COMBS PLACE SUBDIVISION

APPLICATION NUMBER 3 DATE November 17, 2005

REQUEST Subdivision

DETAIL SITE PLAN

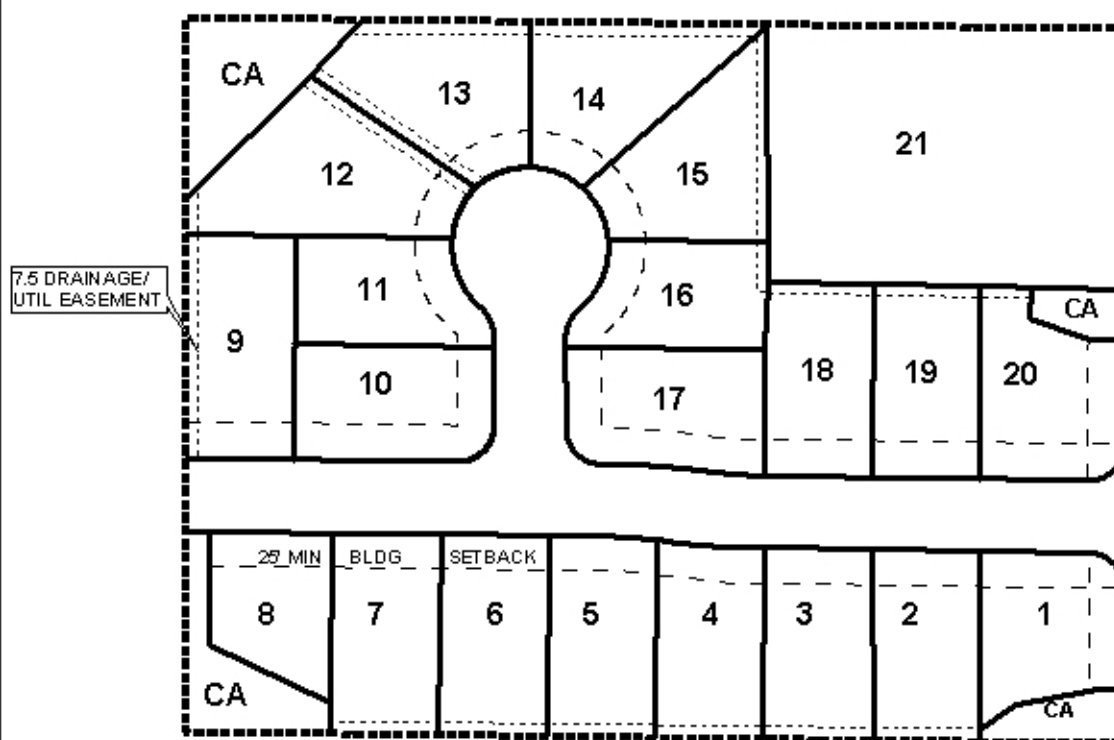
As a means of access management, the placement of a note on the final plat stating that Lots 10 and 17 (which are corner lots) are limited to one curb cut each, with the size, location and design to be approved by Traffic Engineering and Lots 1 and 20 are denied direct access to Grider Road should be required. Additionally, any new roads for the site are to be constructed dedicated and dedicated to meet City of Mobile standards.

Common areas are shown on the plat, thus a note should be placed on the final plat stating that maintenance of all common areas will be the responsibility of the property owners. Access to these areas will be via a 7.5' drainage and utility easement.

The 25-foot minimum building setback lines are not shown but would be required on the final plat.

The plat meets the minimum requirements of the Subdivision Regulations and is recommended for Tentative Approval subject to the following conditions: 1) construction and dedication of new roads to meet City of Mobile standards; 2) the placement of a note on the final plat stating that Lots 10 and 17 (which are corner lots) are limited to one curb cut each, with the size, location and design to be approved by Traffic Engineering and Lots 1 and 20 are denied direct access to Grider Road; 3) the provision of a street stub to the West as shown on plat submitted; 4) the placement of a note on the final plat stating that maintenance of all common areas are the responsibility of the property owners; 5) the placement of the 25-foot minimum setback lines on the final plat; and 6) full compliance with Urban Forestry comments (*Preservation status is to be given to the 35" Live Oak Tree located on the North side of Lot 19. Any work on or under this tree is to be permitted and coordinated with Urban Forestry; removal to be permitted only in the case of disease or impending danger*).
